ADDENDUM #TWO (2)

project Spirit Mountain Chalet
Duluth, Minnesota
project # 011103.00
date May 8, 2012
from John M. Gerzina DSGW Duluth
to All plan holders for above project

A7.2 CIRCULATION SECTIONS, ROOF DETAILS

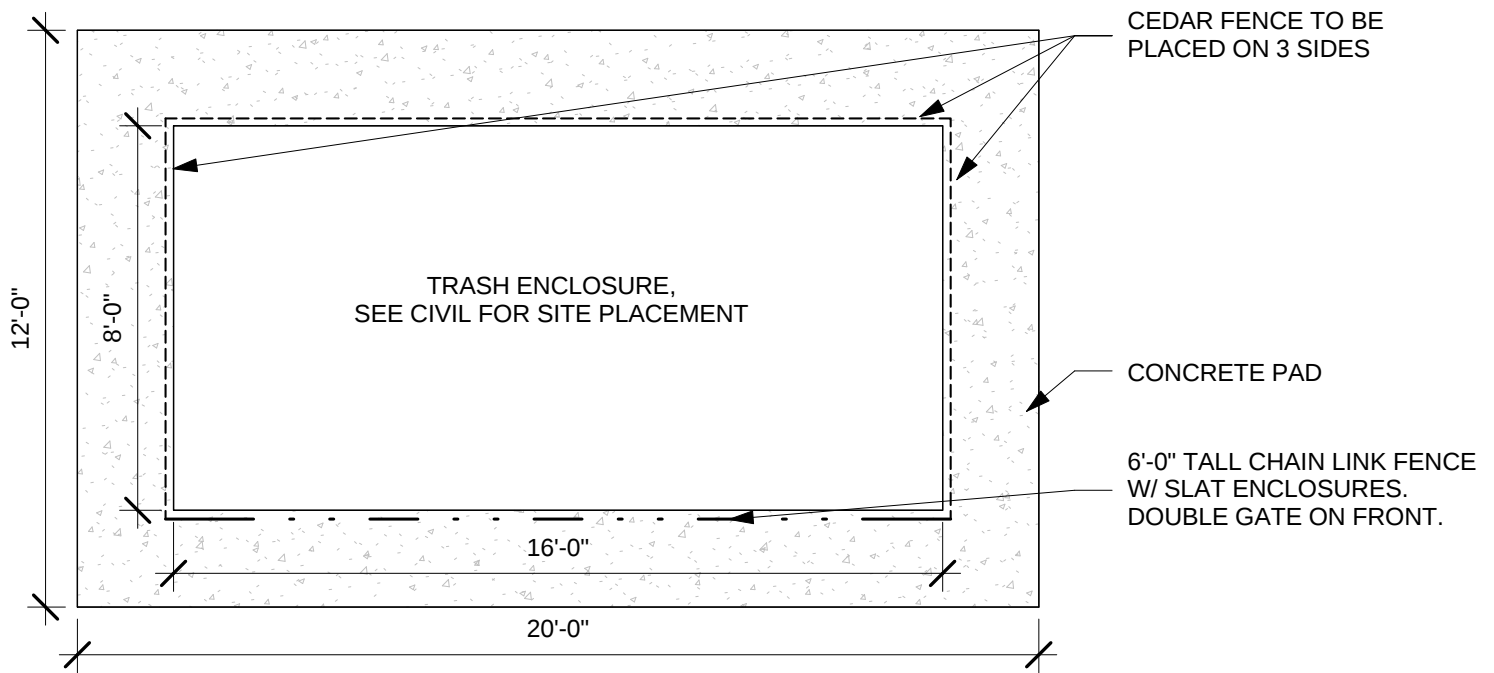
1. 3 & 7/A7.2: CLARIFICATION: There is a ceramic tile base as so noted in the Room Finish Schedule.
2. 7/A7.2: CLARIFICATION: The tread, riser and landing of the stair shall be finished with tile (ST).

1 Trash Enclosure Plan
1/4" = 1'-0"

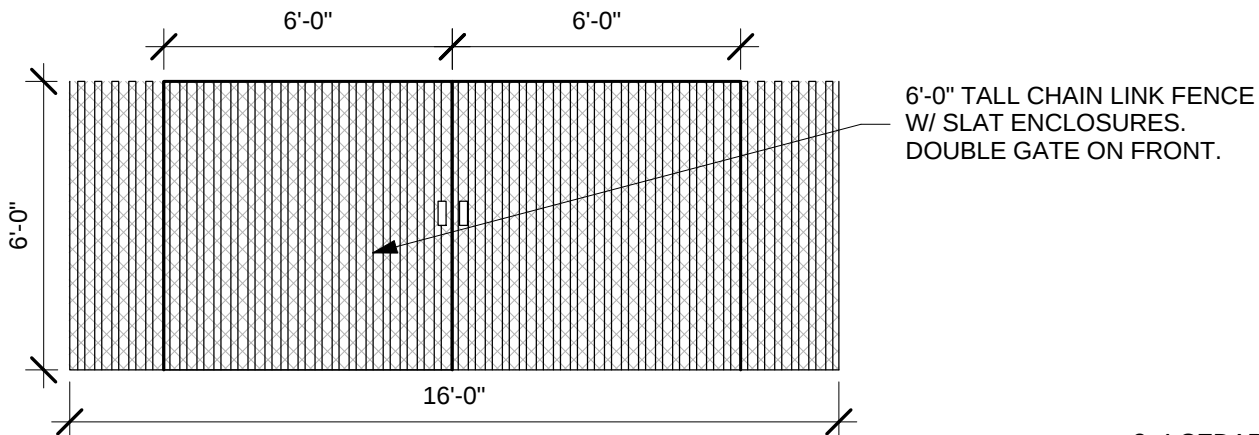
1. See attached drawing 1 of 1 for revisions to the trash enclosure as noted in Addendum #1.
